## **Pig Burn Water Users - Application No. RM20.039**

### **Formal Amendment to Application**

Re: Higher Primary Take Rate at Times of High Flow

Figure 1. Observed take rates for the Kirkwood South and Mulholland takes in October 2017.

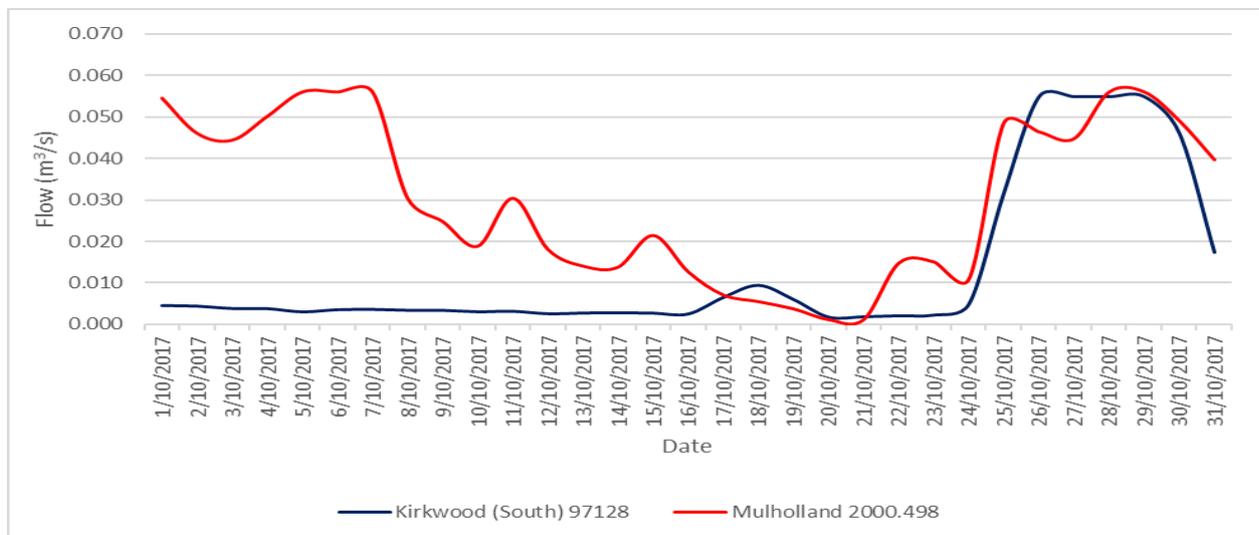
Both the Kirkwood South and the Mulholland takes have consented maximum rates of 56 l/s. Both have historically accessed their maximum consented rate of take both individually and simultaneously (Figure 1). Altering the applications combined rate of take from 60 l/s to 110 l/s is not outside these applicants' history of use.

Historically these takes have operated taking a combined rate of take of 111 l/s and they have done so with no residual flow to maintain. The amendment to the application seeks a combined maximum instantaneous rate of take of 110 l/s at the proposed combined take by Mulholland and Concept/Sophic with a residual flow of 200 l/s below the point of take.

Figure 2. Observed flow at the intake (before taking), the flow regime that would occur under the initial application below the intake and the flow regime that would occur with the proposed amendment (110 l/s take with 200 l/s residual flow).

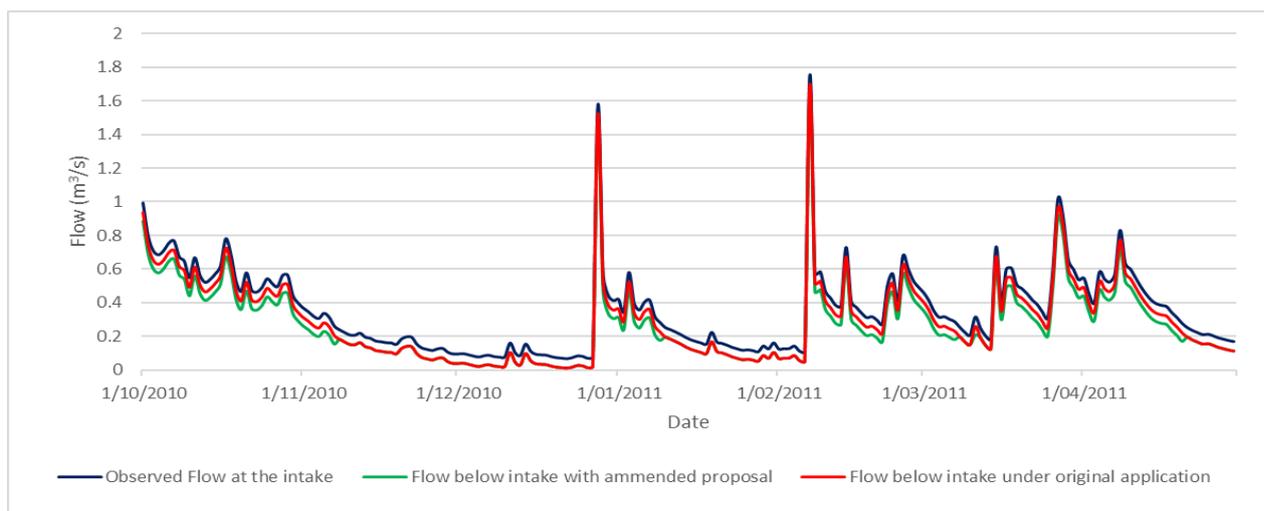
Figure 2 below provides an example of the flow regime expected below the combined take under the controls in the original application (60 l/s max take with 10 l/s residual flow) compared to the flow regime with the proposed amendment (110 l/s maximum take with a 200 l/s residual flow and 60 l/s max take with 10 l/s residual flow).

When interpreting Figure 2 it should be considered conservative as it assumes if the water is there and the residual flow can be met that water is taken. However, in reality the volume constraints on the take would prevent this, meaning that the red and green lines would more closely reflect the blue line, particularly later in the season.

Figure 2 demonstrates that the amendment has minimal effect on flows in the Pig Burn compared to what was originally applied for. Clearly the amendment ensures flow variability would not be affected by the amendment and that when the take is operating more than 60% of the flow at the take will be left instream.
